Title: Cavalon Oil Thermostat Assembly Upgrade		
AG-SB-2020-02-B-EN		Compliance Category: A – MANDATORY B – RECOMMENDED C – OPTIONAL
Applicability		
Aircraft type & model: AutoGyro Cavalon	Affected Serial number(s): All Cavalon fitted with the Rotax 915iS engine up to V00473 but excluding V00398, V00443 & V00450	
The maintenance manual to be referenced is this stated or subsequent issue.		As per AutoGyro website
This form is the response from AutoGyro GmbH either against a problem found in the product in service requiring a containment or rectification action, or as service information for aircraft modification incorporation. For help, contact AutoGyro on +49(0)5121 88056-00, or email airworthiness@auto-gyro.com.

Reason and overview of the Service Bulletin (cause of problem if known)

(Pic. 2)

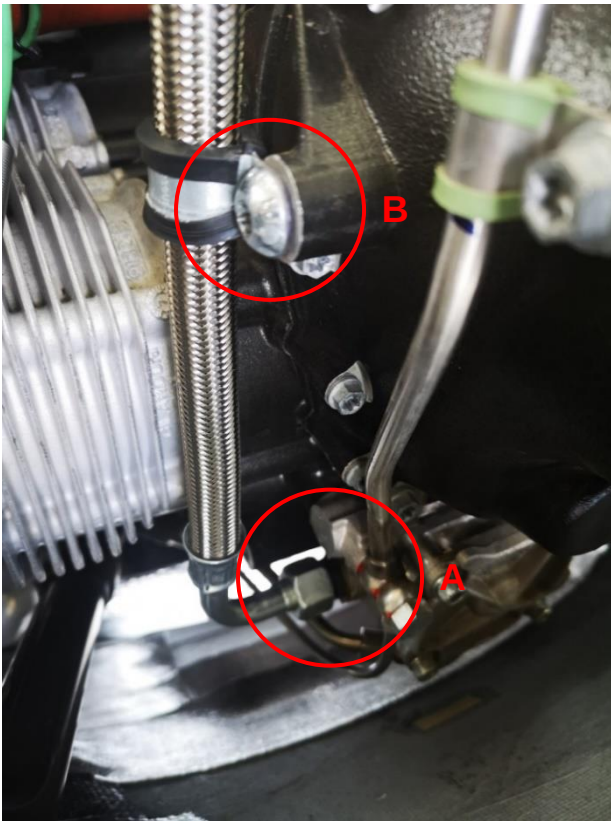
5. Confirm the size of the adapter at the oil cooler (Pic. 2). If the thread size is 18mm then adapter **45534** is required. If the thread is 22mm then no further action is required.

8. Disconnect the return hose from the right side oil cooler at the oil tank connection (Pic 2, item C)
9. Place a container under the oil cooler hose connections and disconnect the 4 hoses from the oil coolers (Pic 3. Items D, E, F & G). NOTE: Ensure to counter the adapters when dis-assembling and assembling the hoses on the coolers.
Note: The thermostat and hoses are now supplied as separate items.

(Pic. 1)

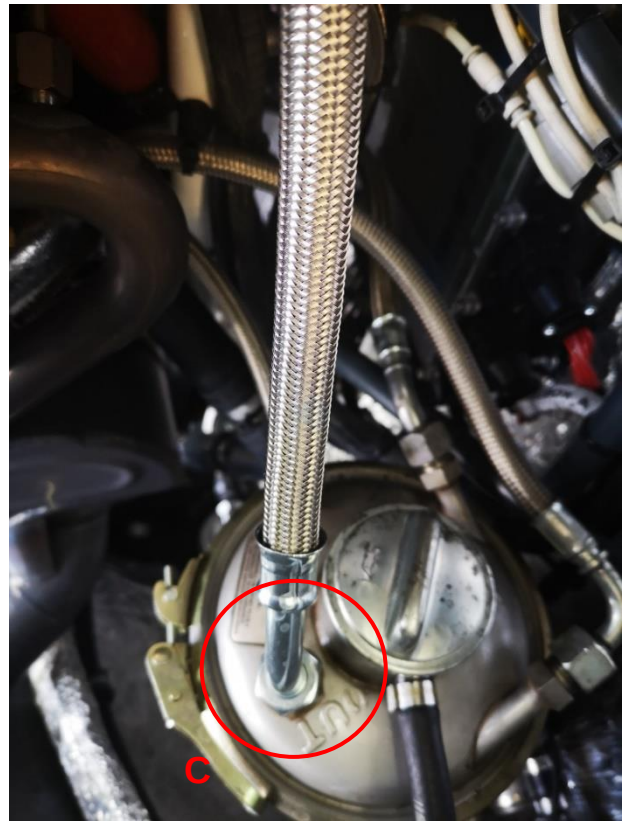
4. Confirm the size of the adaptor at the oil pump (Pic. 1 item A). If the thread size is anything other than 22mm then it must be replaced with adapter **45583**. If the thread is 22mm then no further action is required.

6. Return the oil in the system to the tank by turning the propeller until a gurgling sound is heard.
7. Place a container under the oil pump at the rear of the engine, and disconnect the oil hose (Pic. 1, item A). Allow any oil to drain and remove the P-clamp (Pic. 1, item B).

(Pic. 3)

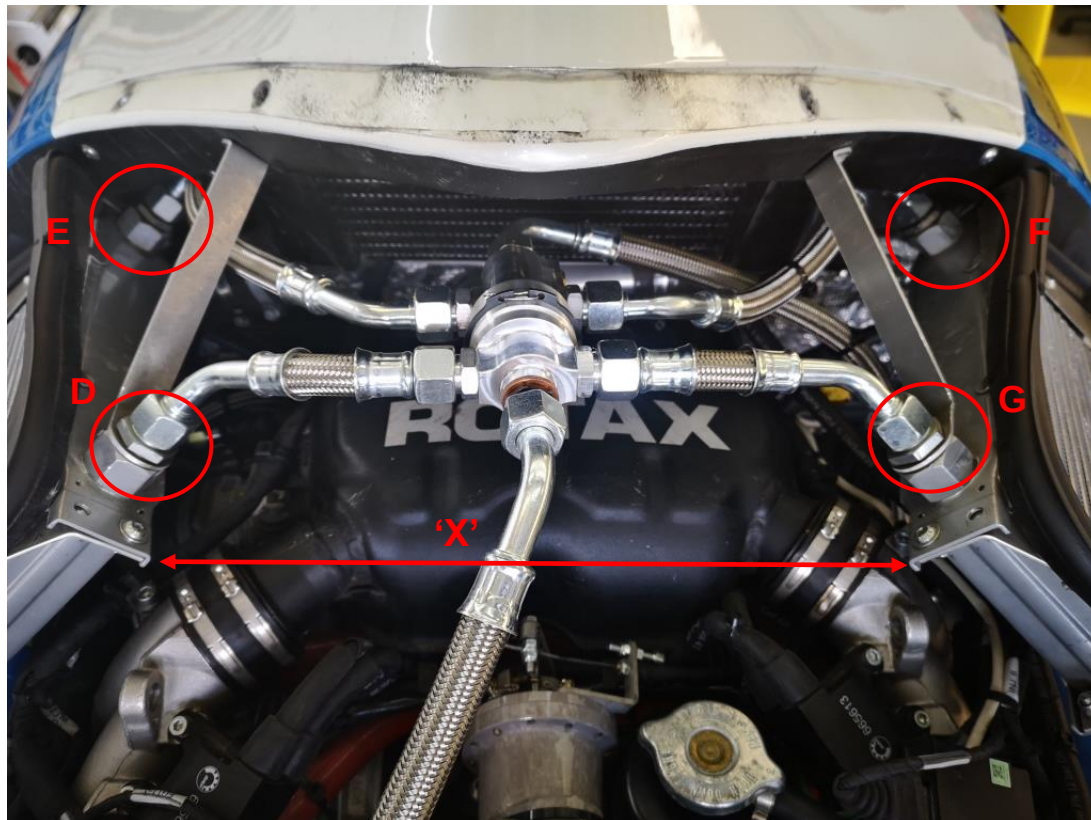
1. Ensure the wheel brakes are applied and the mag switches/ignition are switched in the "off" position.
2. Remove the upper and lower engine cowlings.
3. Measure the distance between the oil cooler corners as shown in Pic. 3 dimension 'X' to determine which hose set is required. If dimension 'X' is 280mm then oil hose set **47896** is required, if dimension 'X' is 335mm then oil hose set **47817** is required.

(Pic. 4)

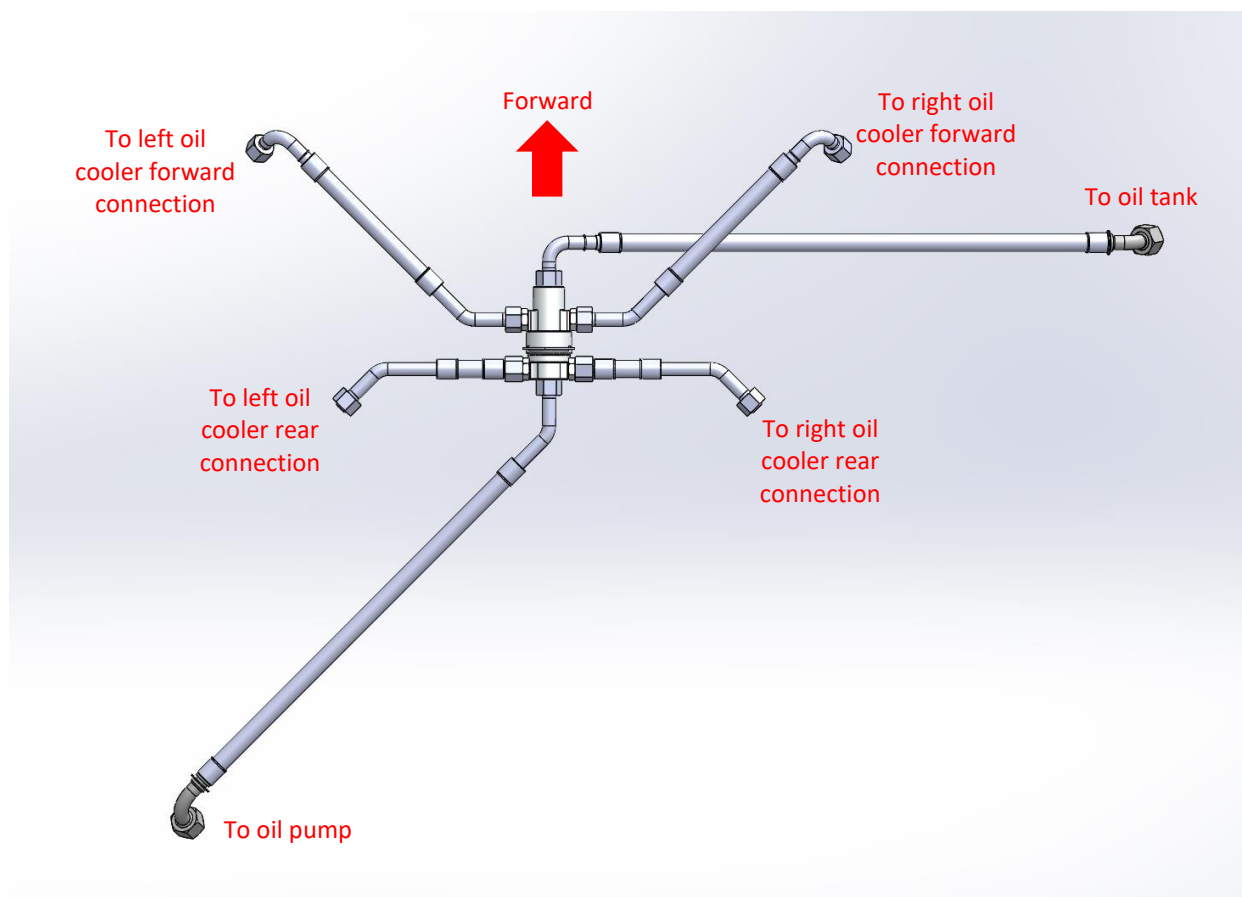
10. Assemble the new hoses (47896 or 47817) to the new thermostat (47748) loosely. Ensure that the items are assembled in the correct orientation as shown in Pic. 4.
